Drawing Revision M – WSCC 18/09/08

Job Title
Eden Park
Littlehampton

Drawing Title
Engineering Layout : 1:500

Drg. No.	Rev.
1811/201	N

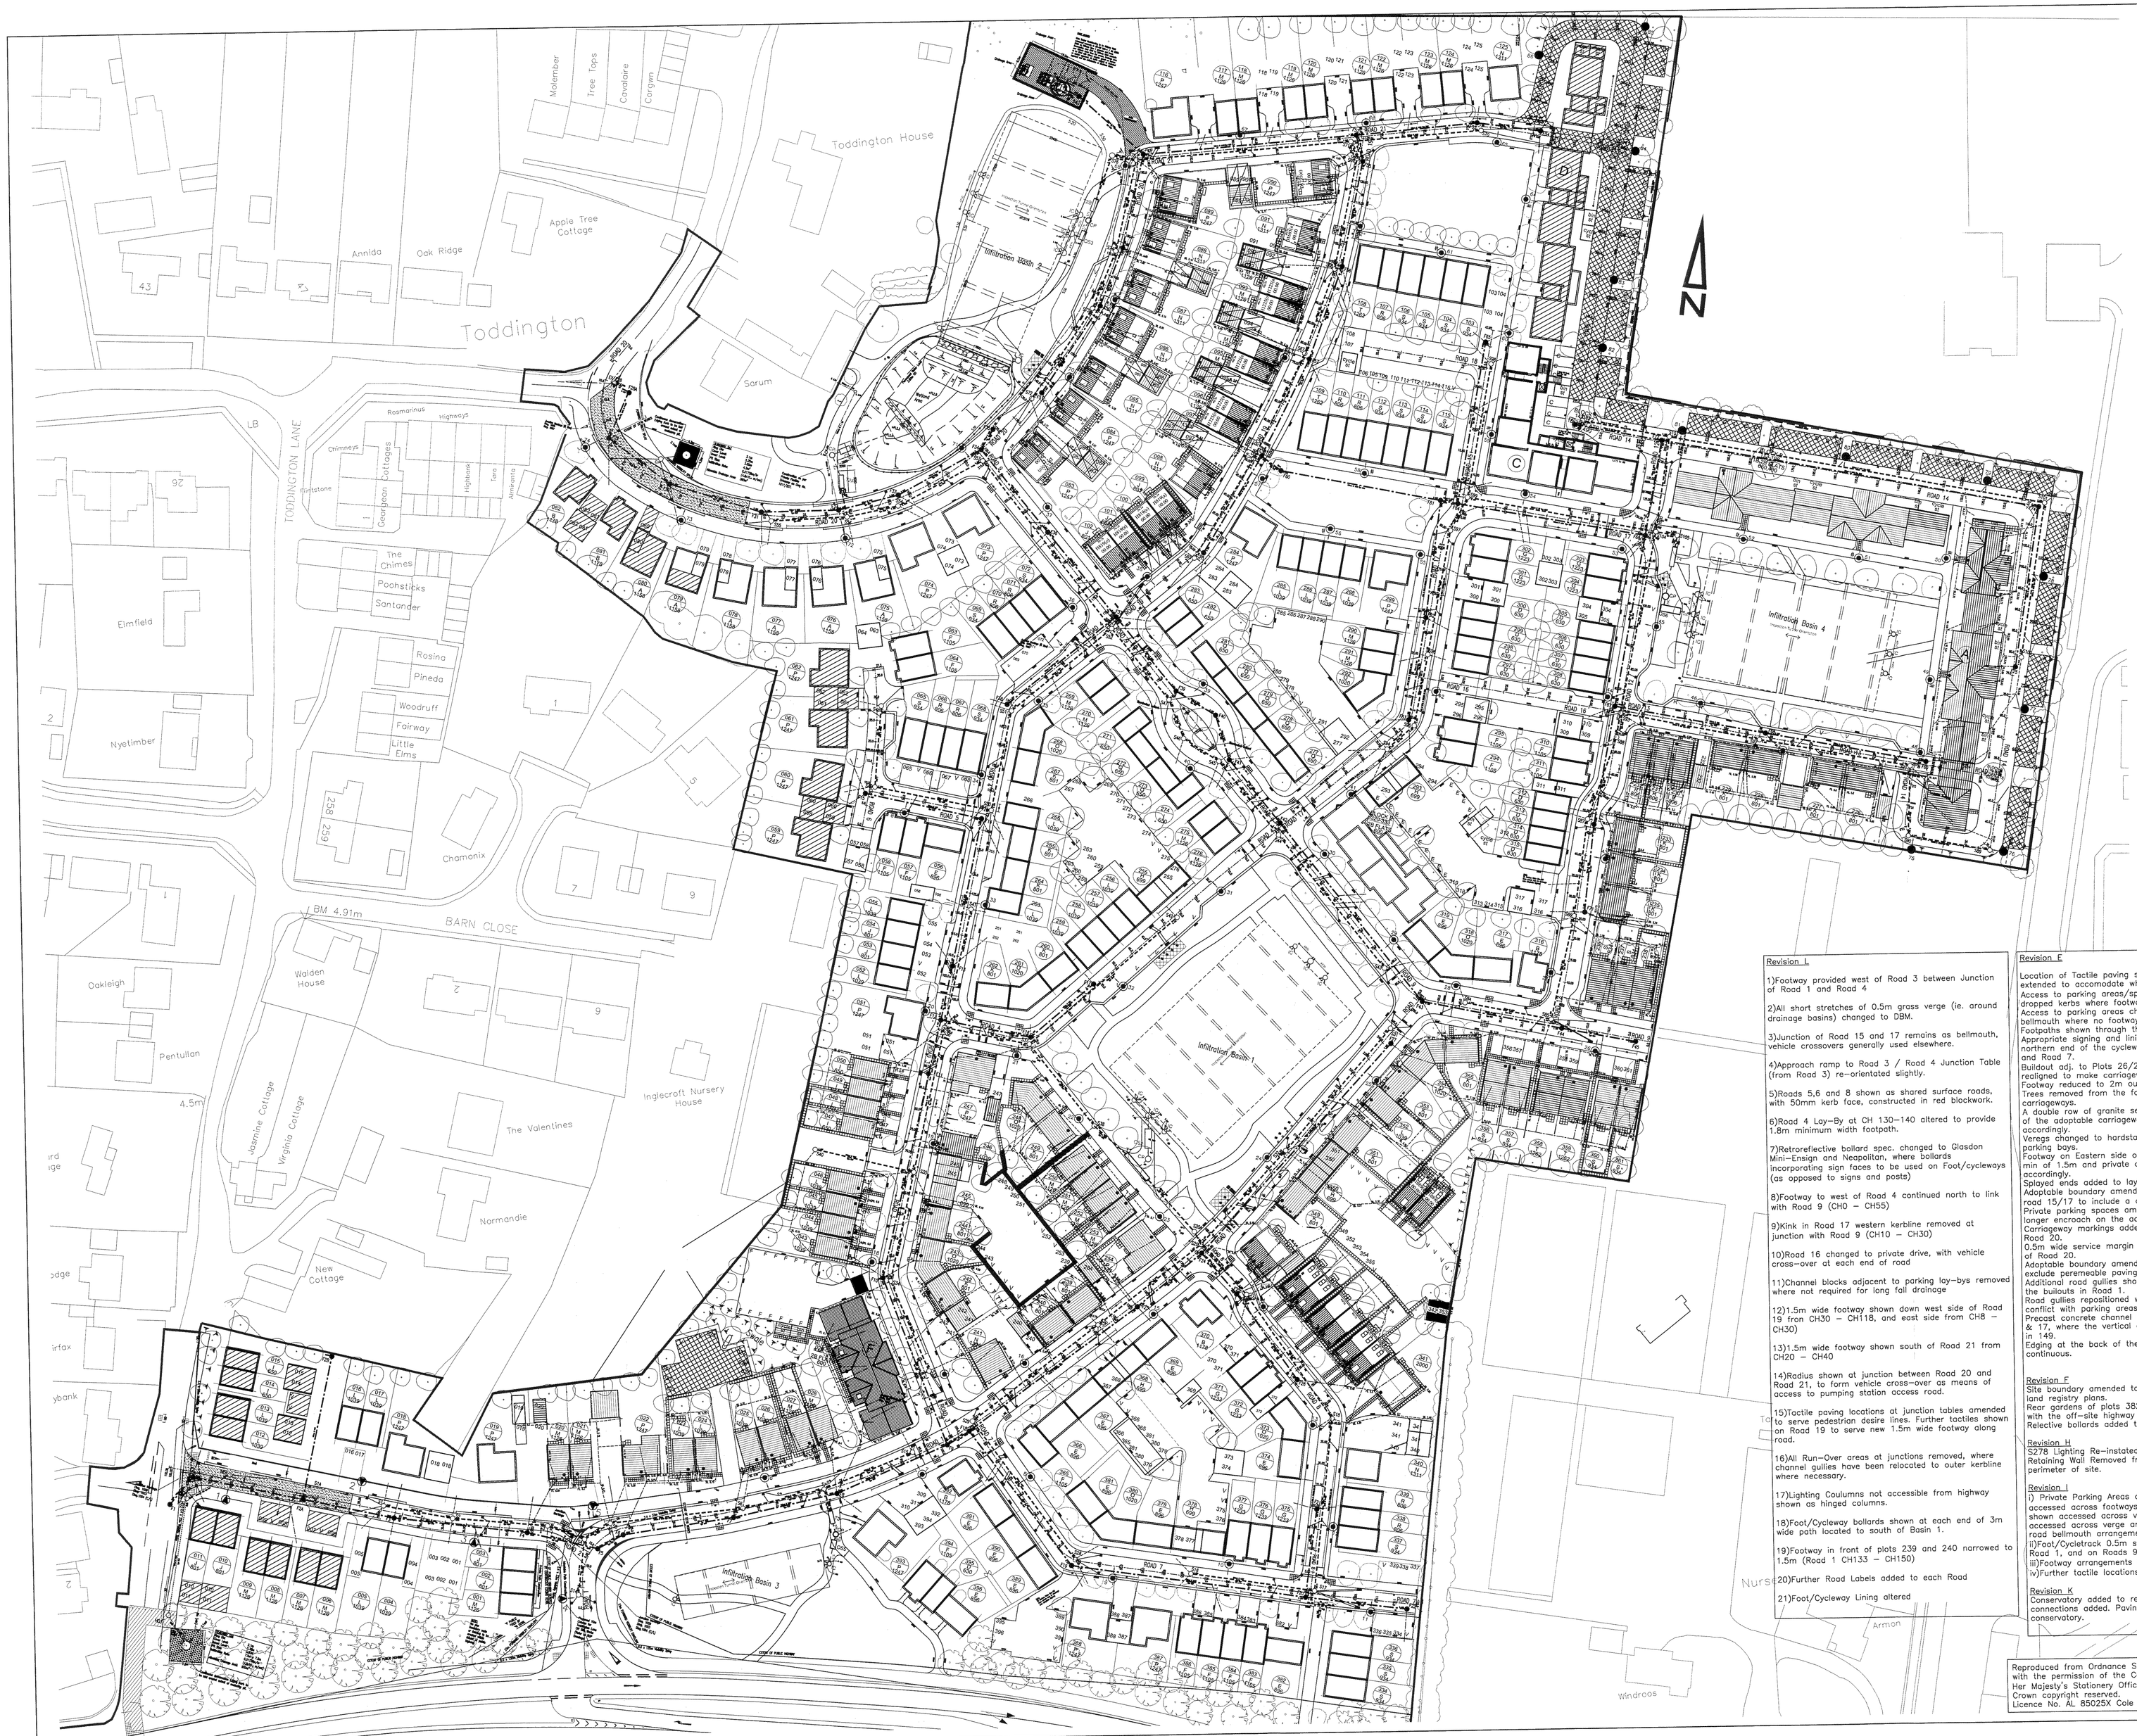
1. Edging kerbs shown across the end of the footways in line with the HB2 kerbs at the end of Roads 7 and 9.
2. Back of footway edging kerbs extended to the site boundary.

3. Pumping Station amended to As Built Layout.
4. All kerblines shown for Roads 7, 17 and 19.
5. Channel blocks in Road 17 extended to gullies.
6. Bellmouth–type vehicular crossovers for parking plots 226–229 changed to dropped kerb crossings in Road 13.

7. Grass area adjacent to Plot 370 in Road 8 changed to tarmac margin.
8. Bollards on Buildouts shown as Glasdon Neopolitan to WSCC Spec.
9. Bollards on Shared Foot/Cycleways shown as Glasdon Mini–Ensign to WSCC Spec.

10. Additional Tactile Crossing Points shown at the junctions of Roads 9/12 and on Road 19 o/s Plot 91.
11. Gullies shown at the eastern end of Road 16 behind the back of the adoptable footway/crossover off Road 12.

12. Superseded SW sewer from S20 in Road 1 removed from drawing.
13. LC 68 (Road 20/21) relocated within adoptable highway.
14. LCs 35 (Road 4) and 54 (Road 17) shown within the back of the adoptable footway.

15. LC 44 relocated north of the crossover between road 12 and 16.
16. LC 48 to be relocated inside the 2m wide footway.
17. Existing LCs in the A259 Worthing Road shown.

18. Rear garden fences of Plots 382–384 realigned it outside existing A259 Worthing Road Highway boundary.
19. List of Section 38 Drawings shown.

1)Footway provided west of Road 3 between Junction of Road 1 and Road 4

2)All short stretches of 0.5m grass verge (ie. around drainage basins) changed to DBM.

3)Junction of Road 15 and 17 remains as bellmouth, vehicle crossovers generally used elsewhere.

4)Approach ramp to Road 3 / Road 4 Junction Table (from Road 3) re–orientated slightly.

5)Roads 5,6 and 8 shown as shared surface roads, with 50mm kerb face, constructed in red blockwork.

6)Road 4 Lay–By at CH 130–140 altered to provide 1.8m minimum width footpath.

7)Retroreflective bollard spec. changed to Glasdon Mini–Ensign and Neapolitan, where bollards incorporating sign faces to be used on Foot/cycleways (as opposed to signs and posts)

8)Footway to west of Road 4 continued north to link with Road 9 (CH0 – CH55)

9)Kink in Road 17 western kerbline removed at junction with Road 9 (CH10 – CH30)

10)Road 16 changed to private drive, with vehicle cross–over at each end of road

11)Channel blocks adjacent to parking lay–bys removed where not required for long fall drainage

12)1.5m wide footway shown down west side of Road 19 fron CH30 – CH118, and east side from CH8 – CH30)

13)1.5m wide footway shown south of Road 21 from CH20 – CH40

14)Radius shown at junction between Road 20 and Road 21, to form vehicle cross–over as means of access to pumping station access road.

15)Tactile paving locations at junction tables amended to serve pedestrian desire lines. Further tactiles shown on Road 19 to serve new 1.5m wide footway along road.

16)All Run–Over areas at junctions removed, where channel gullies have been relocated to outer kerbline where necessary.

17)Lighting Coulumns not accessible from highway shown as hinged columns.

18)Foot/Cycleway bollards shown at each end of 3m wide path located to south of Basin 1.

19)Footway in front of plots 239 and 240 narrowed to 1.5m (Road 1 CH133 – CH150)

Location of Tactile paving shown and footpaths extended to accomodate where required.
Access to parking areas/spaces changed to dropped kerbs where footway is present.
Access to parking areas changed to small bellmouth where no footway is present.
Footpaths shown through the public open spaces.
Appropriate signing and lining shown on the northern end of the cycleway linking Worthing Road and Road 7.
Buildout adj. to Plots 26/27 made continuous and realigned to make carriageway continuous.
Footway reduced to 2m outside Plot 241.
Trees removed from the footways and carriageways.
A double row of granite setts shown at the back of the adoptable carriageway and gullies altered accordingly.
Verges changed to hardstanding behind on–street parking bays.
Footway on Eastern side of Road 12 increased to min of 1.5m and private drainage repositioned accordingly.
Splayed ends added to layby in Road 13.
Adoptable boundary amended at the junction of road 15/17 to include a crossing point.

Private parking spaces amended so that they no longer encroach on the adoptable area.
Carriageway markings added to the beginning of Road 20.
0.5m wide service margin shown across the end of Road 20.
Adoptable boundary amended on Road 21 to exclude permeable paving.
Additional road gullies shown on the high side of the buildouts in Road 1.
Road gullies repositioned where possible to avoid conflict with parking areas.
Precast concrete channel blocks shown in Roads 8 & 17, where the vertical alignment is less than 1 in 149.
Edging at the back of the grass margin shown as continuous.

Revision F
Site boundary amended to reflect boundary on land registry plans.
Rear gardens of plots 382–384 amended in line with the off–site highway works adoption boundary.
Relective bollards added to buildouts.

Revision H
S278 Lighting Re–instated to drawing
Retaining Wall Removed from north eastern perimeter of site.

Revision I
i) Private Parking Areas and private Driveways accessed across footways or foot/cycleways, shown accessed across vehicle crossovers. Those accessed across verge area, shown accessed by road bellmouth arrangements
ii)Foot/Cycletrack 0.5m safety zone shown on Road 1, and on Roads 9 and 20
iii)Footway arrangements in Basin areas shown
iv)Further tactile locations shown

Revision K
Conservatory added to rear of Plot 23, SW drain connections added. Paving slabs moved to rear of conservatory.
